**Re: Response to Comments**  
**Zoning By-law Amendment Application RZ 2020-0007**  
**8281 and 0 Healey Road, Caledon**  
**Part Lot 5, Concession 5 (Albion)**  
**Zelinka Priamo Ltd., on behalf of 8281 Healey Road GP Ltd. c/o One Properties**

**TRCA COMMENTS ON Region File # RZ2020-007 - FIRST SUBMISSION (TRCA FILE # CFN 62592.02)**

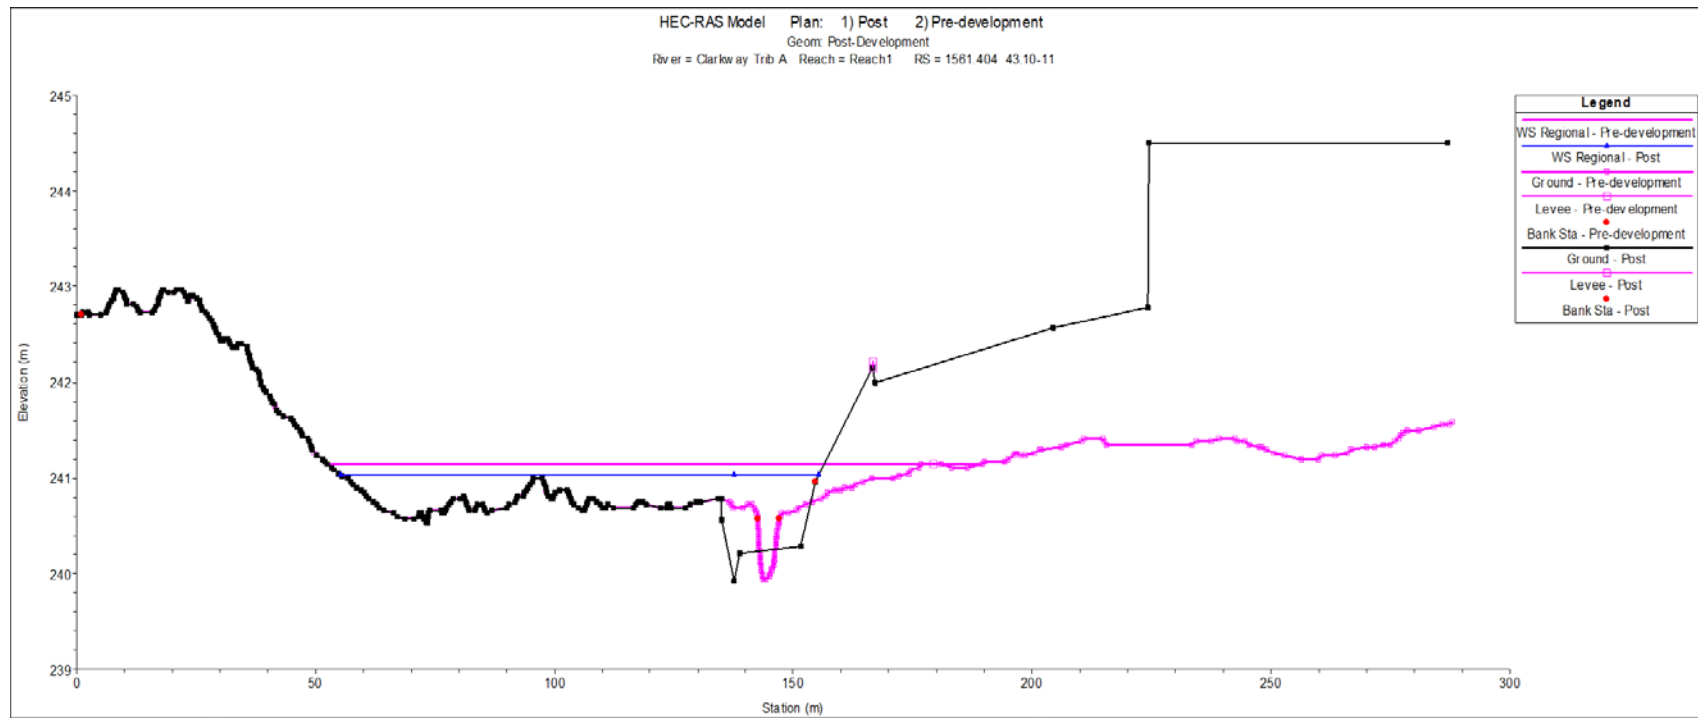
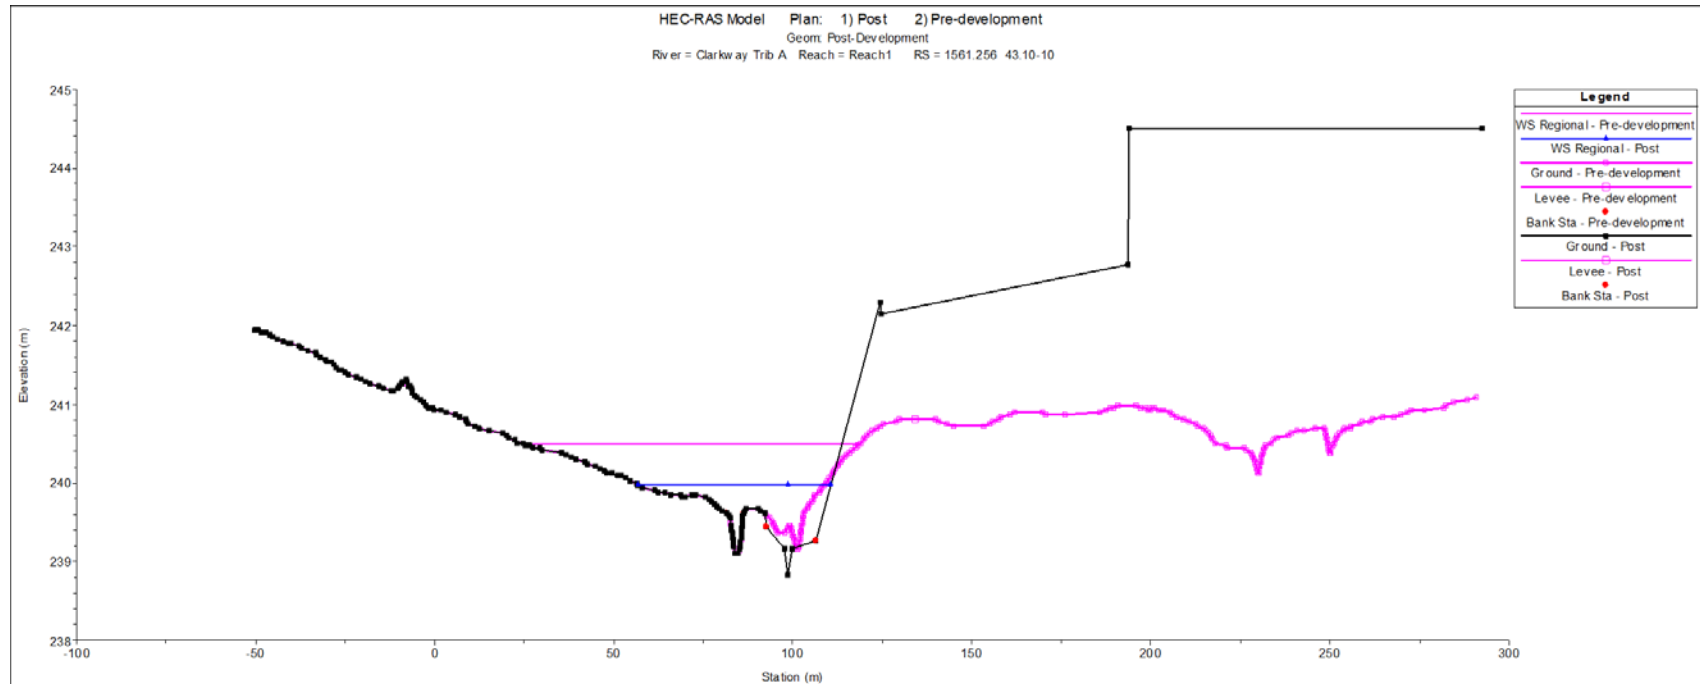
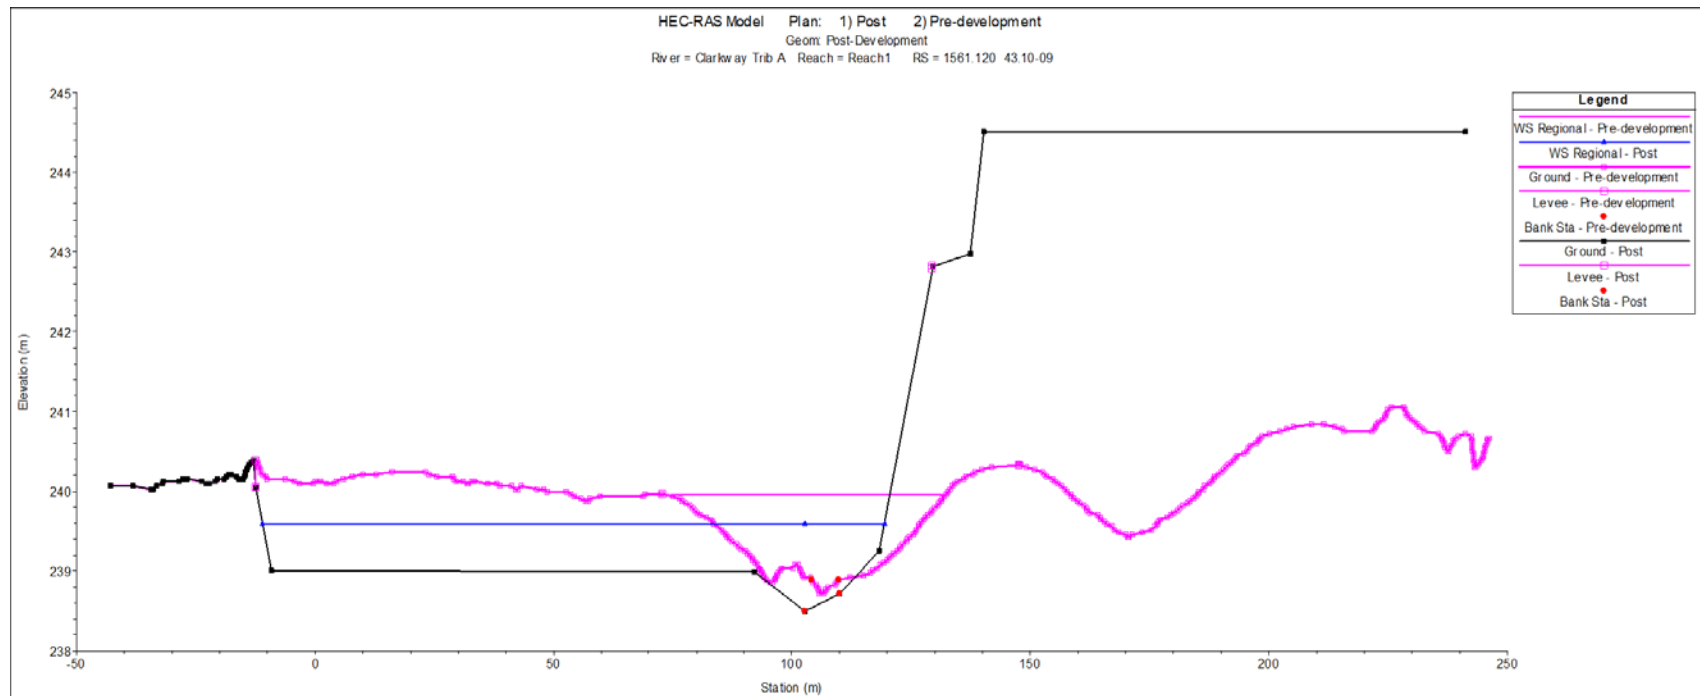
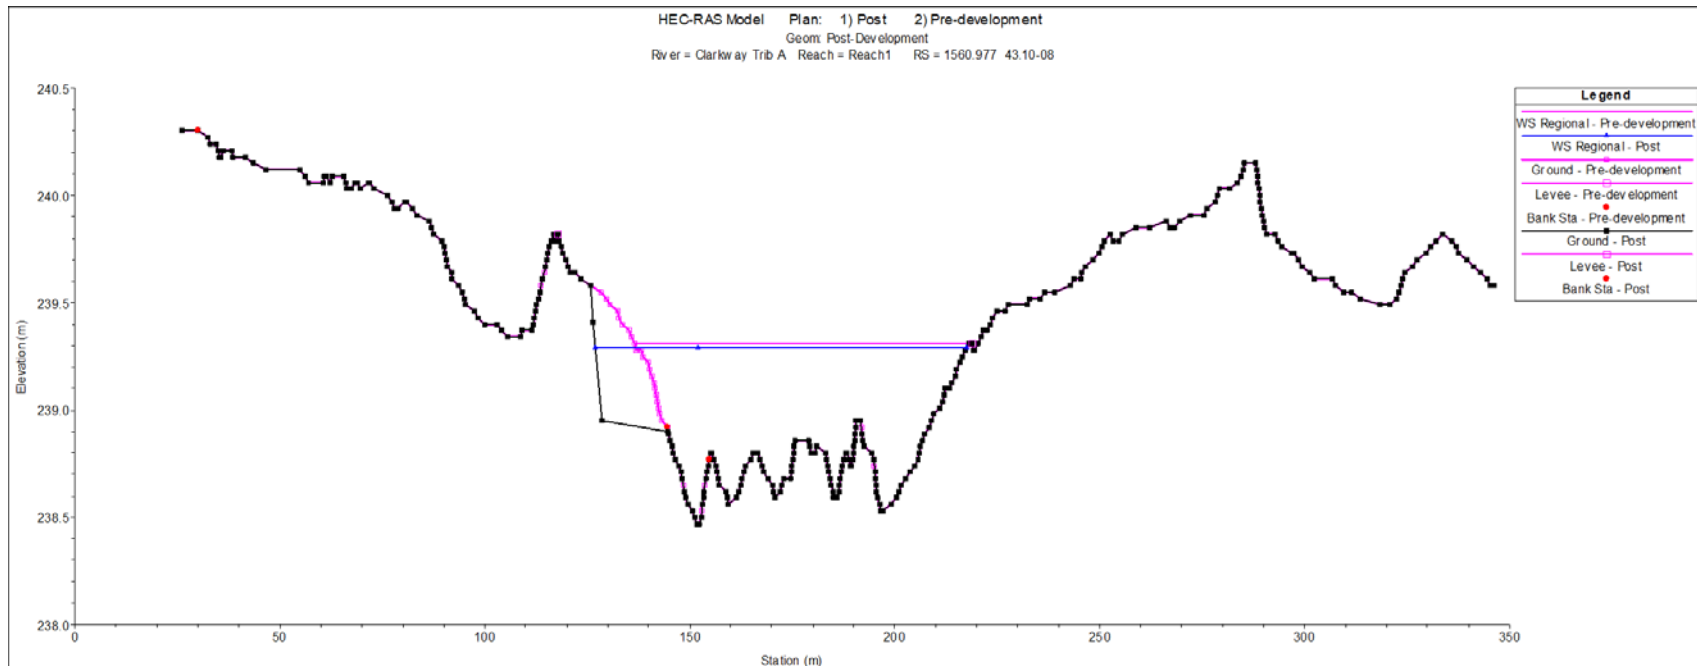
18. TRCA staff compared the existing and proposed cross sections extracted from the respective models and the comparison (see below) shows that according to the proposed cross sections in the proposed condition HEC-RAS model, although the submitted Figures show proposed grading is within the property limit, the grading exercise appears to extend beyond the property line. Please confirm that the grading shown within the HEC-RAS model are consistent with the Figures.

- The HEC-RAS Sections have been reviewed and revised based on the above comment. The grading is within the proposed property limit and the HEC-RAS Sections have been updated to match with the HEC-RAS Model Stations and UTM locations between the survey and HEC-RAS Model and Plans.
